Erection of house in garden ground

AddressGarden ground to east of
4 Strips of Craigie Road
Dundee**Applicant**Mr & Mrs Gowans
4 Strips of Craigie Road
Dundee
DD4 7PZ**Agent**Ron Weir
Balloch Bungalow
South Balloch Farm
Alyth
Perthshire
PH11 8JN**Registered** 10 Feb 2009**Case Officer** Julie Young

Proposal for New House in Strips of Craigie Road

The erection of a house in garden ground is **RECOMMENDED FOR REFUSAL**. Report by Director of Planning and Transportation

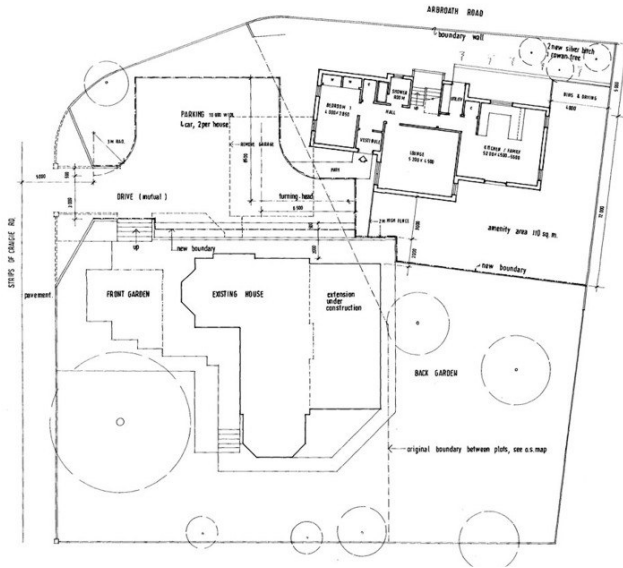
Planning permission is sought to erect a one and a half storey house in garden ground to the east of the 4 Strips of Craigie Road and on the south side of Arbroath Road. The proposal includes the demolition of an existing double garage to the north of the original house and the proposed house will be built on this site at the north end of the garden, which gently slopes upwards towards Arbroath Road. There will be 5m between the proposed and existing houses.

In relation to garden ground, it is indicated on the submitted plans that 110m² of amenity space will be provided, which is not sufficient in terms of complying with Policy 4 requirements. There will be over 300m² garden ground remaining to the east and south of the original house.

- a The proposal is of high quality design and uses materials appropriate to its surroundings. In this case it is considered that the materials of the proposed house are satisfactory in terms of integrating with surrounding properties. It is considered that due to the gradient of the site it will sit at a very prominent location, when viewed from Arbroath Road. When travelling west along Arbroath Road, there is a pattern of large two storey detached houses and the proposed house will be very different in style and height. It is concluded that the proposal does not comply with part A of Policy 15.

The proposed finishing materials are beige roughcast walls and concrete tiles for the roof. It is considered that the design of the proposed house is satisfactory however the height is not considered acceptable as it will result in an overly-dominant development at this prominent location.
